Lower Hill Redevelopment

First Amendment to Preliminary Land Development Plan

Pittsburgh Arena Real Estate Redevelopment LP
July 25, 2022
Revised: November 4, 2022

Amendment to Section 1: Introduction & Section 2: Regulating Plans

Figure 7.3 Enlarged illustrative plan showing a small adjacent pavilion /restaurant with an outdoor dining terrace, pylon marking the entry plaza, and a tree-lined promenade.

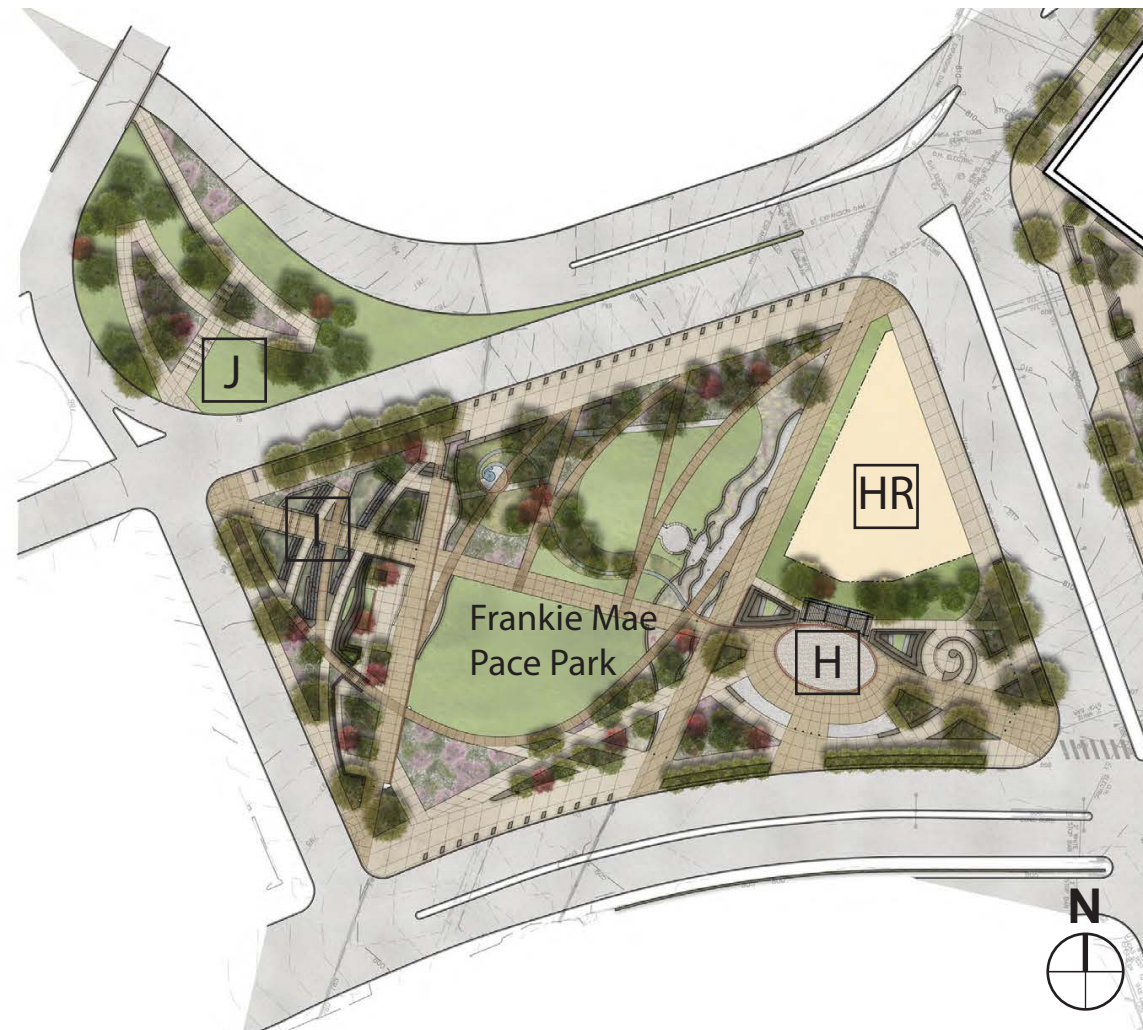
Figures 7.3, 7.4, 7.9, and 7.16 are revised accordingly.

Updates to Figure 7.3, 7.4, shown below

Figure 7.9 Enlarged illustrative plan showing the layout of open space in Block F and G

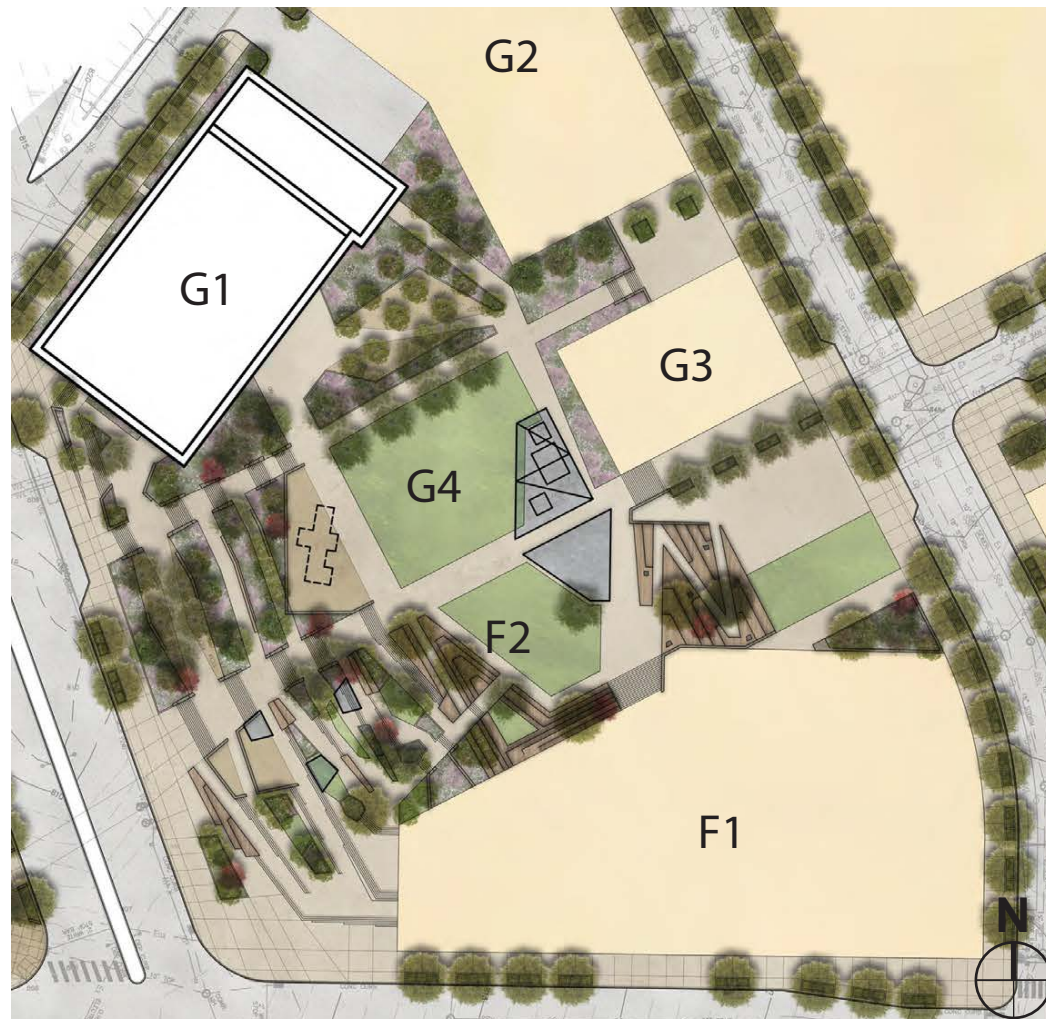
Updates to Figure 7.9 and 7.16 shown below

Figure 7.23 Plan showing potential locations of art installations.

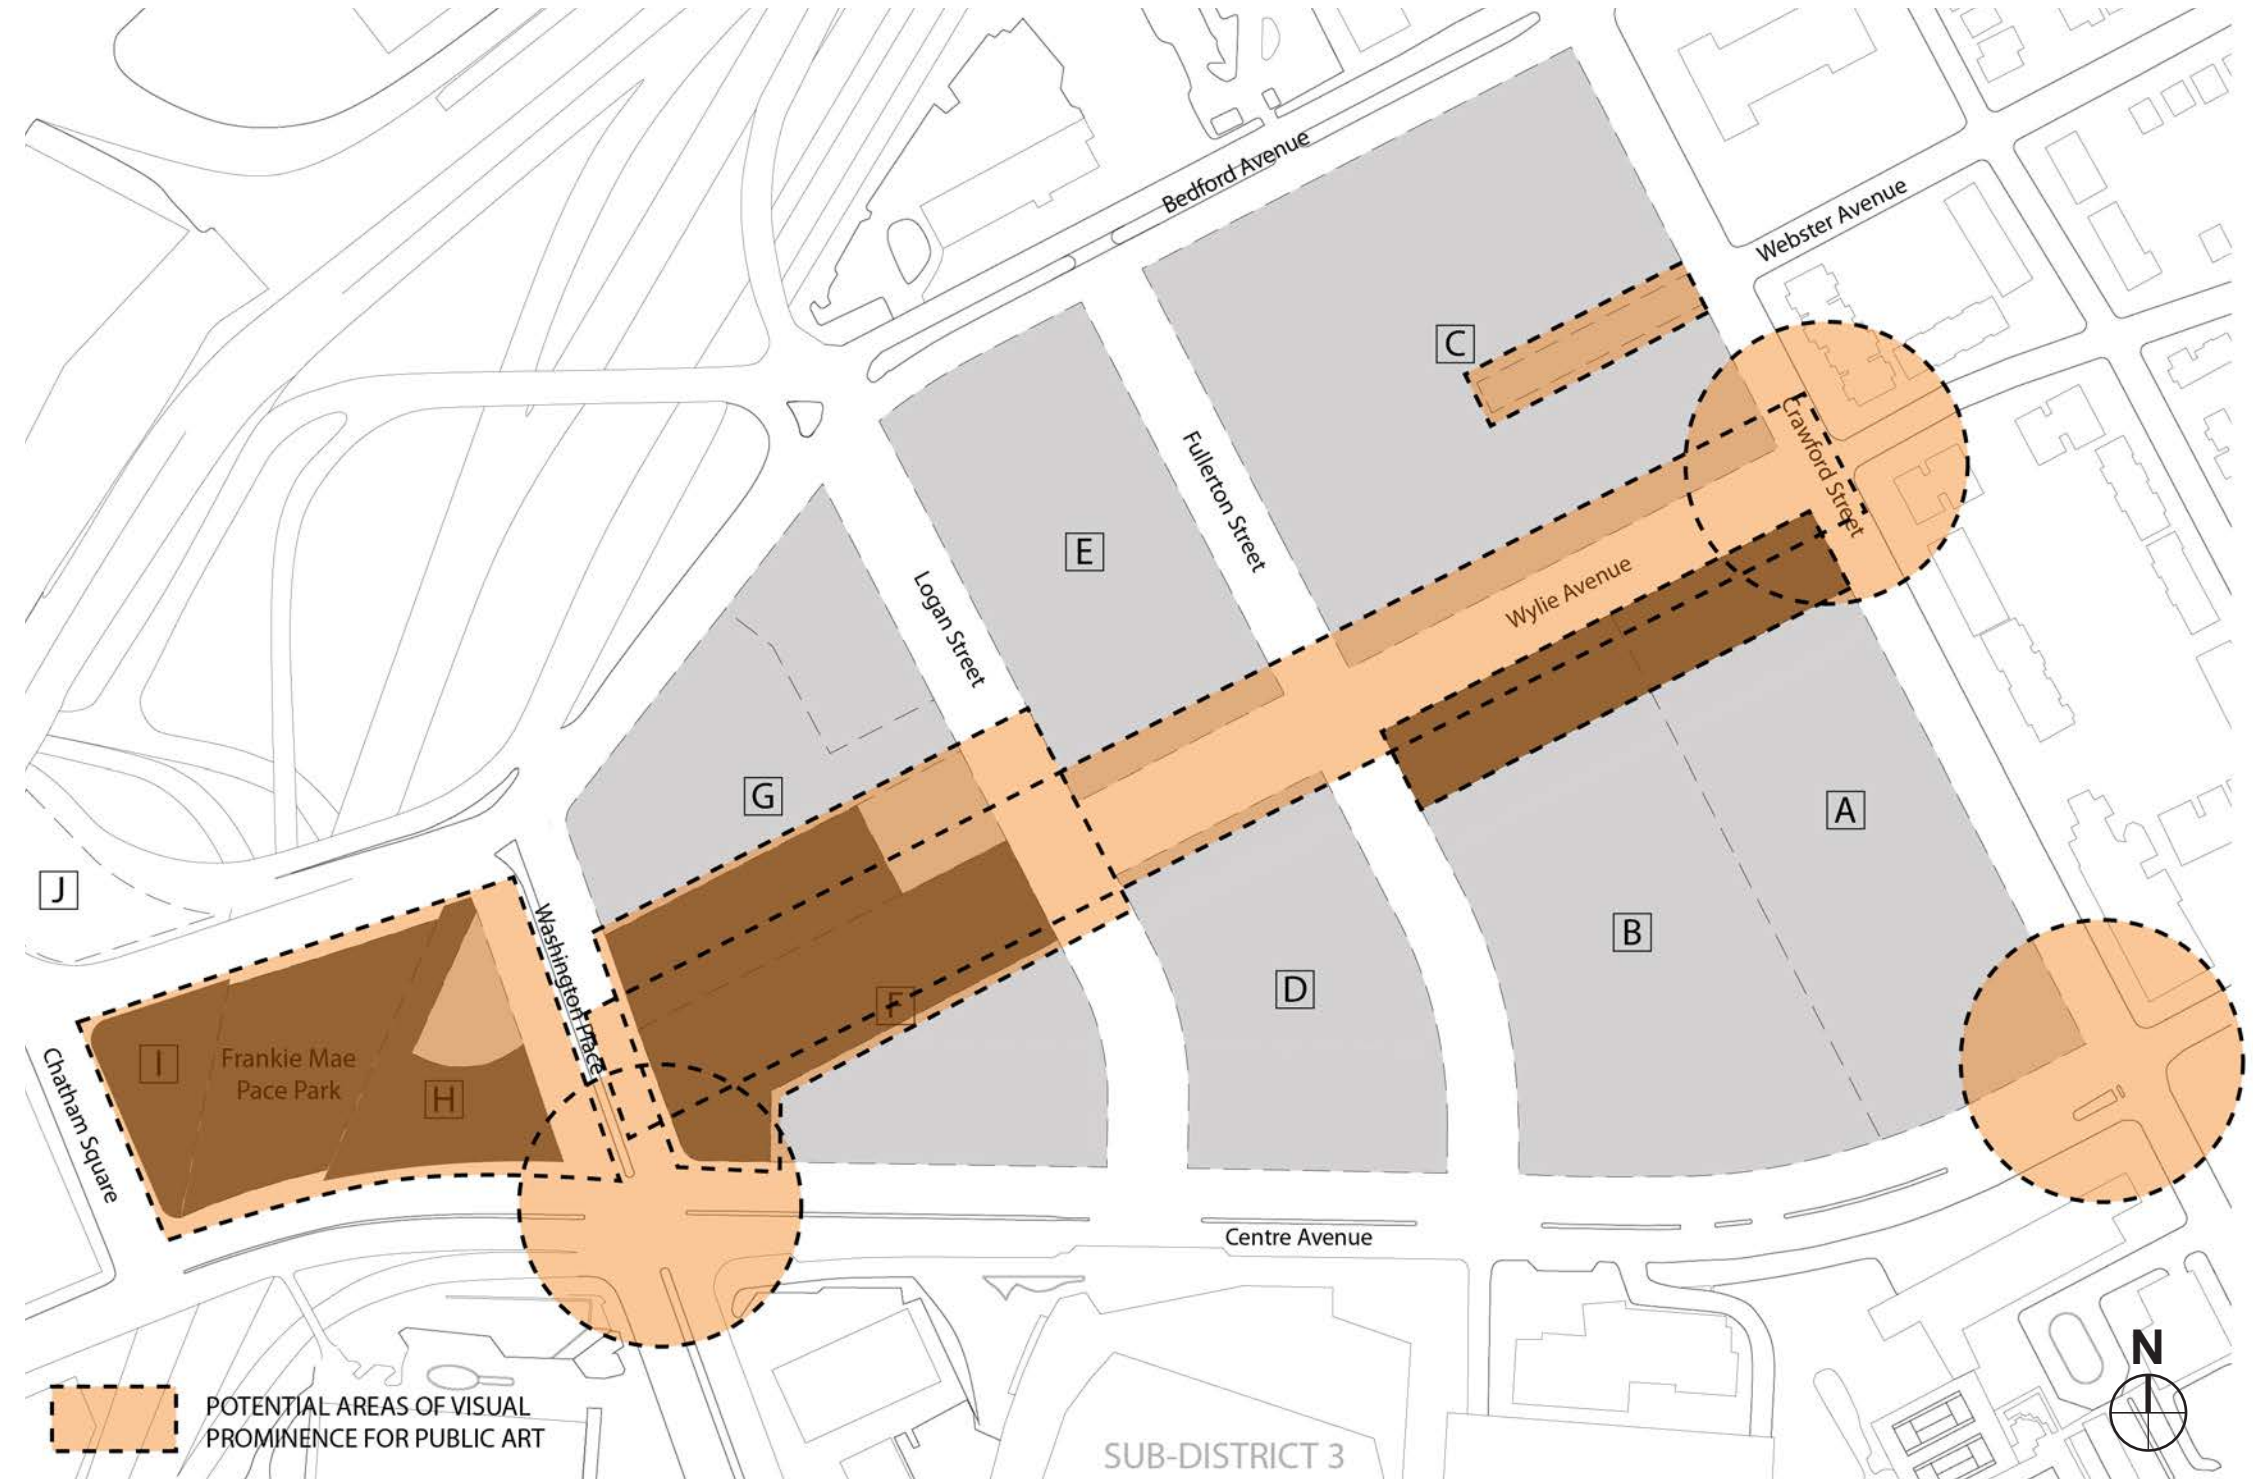
Figure 7.23 is revised to reflect the Block and Urban Open Space revisions identified in Section 7.2.

Updates to Figure 7.23 Shown right
